THE GIBSON

A NEW FREMONT RESIDENTIAL
APARTMENT BUILDING

3421 & 3422 WOODLAND PARK
AVE N, SEATTLE WA
3032609-EG
3029623-LU

RECOMMENDATION
MEETING: MONDAY, NOVEMBER 23RD, 2020

Day Rendering of proposed project at Recommendation Stage ^

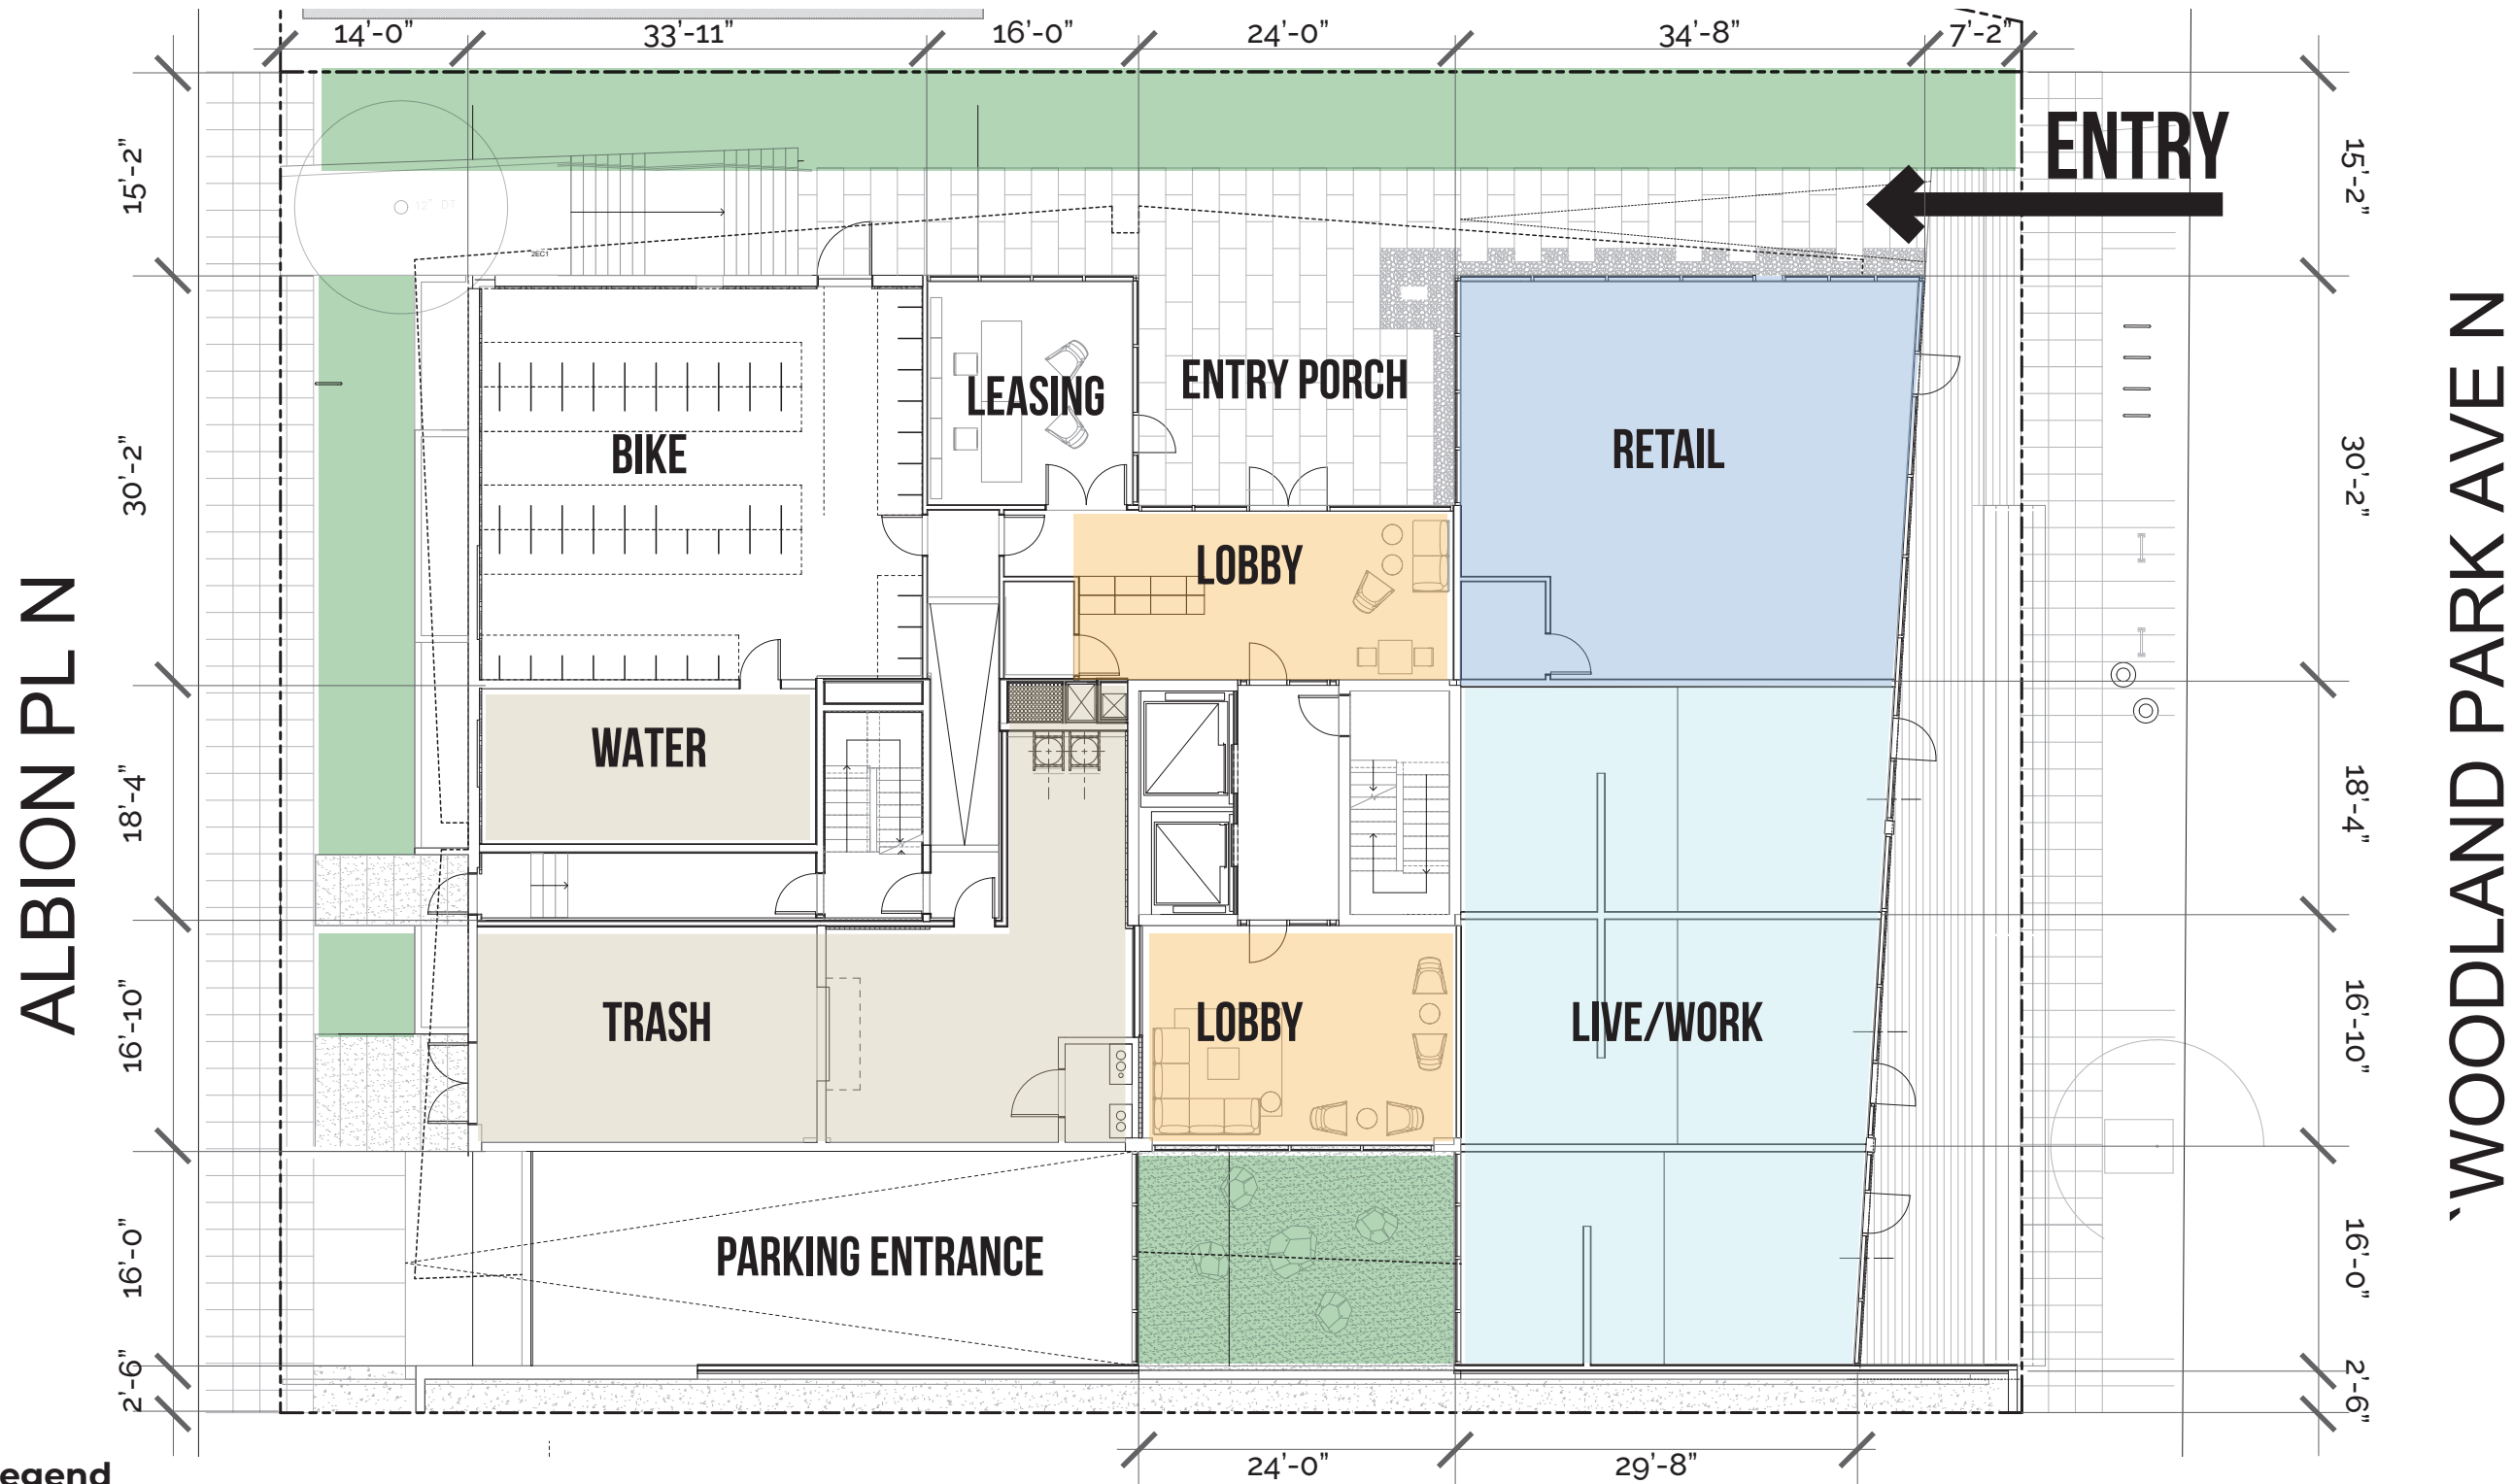
- a. The Board supported the proposed location of the rooftop amenity on the south side of the penthouse - away from the less intense residential zones - as it promotes respect for adjacent sites. (CS2-D-5, DC3-B)
- b. In response to public comment, the Board noted that the rooftop will be perceived as a fifth elevation from the bridge and higher elevations. The penthouse should be designed to be sculptural, informed by the overall architectural concept and inspired by the character of the Fremont neighborhood. (CS3-A, DC2, DC2-B-1, DC3)
- c. The Board encouraged the incorporation of existing vegetation where possible, and directed further consideration of conifers in the landscape design. The Board specifically prioritized Design Guideline DC4-D, Trees, Landscape and Hardscape Materials. (DC4-D)

- b. In response to Board guidance and public comment, the rooftop has been carefully considered in order to promote a more sculptural quality to this aspect of the design. The penthouse itself is imagined as an internally LED light beacon for the community, walls being made up of a transparent, wall panel system. The LED lighting system and general glow of the sky box will add artistic simplicity to the roof amenity area.

- c. A full landscape design has been incorporated in the packet and includes preserving the sidewalk and planting strip location along Albion Place, preserving the streetscape along the west edge of the project. Additional attention was given to an internal courtyard at the south and along the entry sequence near the east and the north. A douglas fir species has been incorporated near the through entry on the northwest corner of the site.
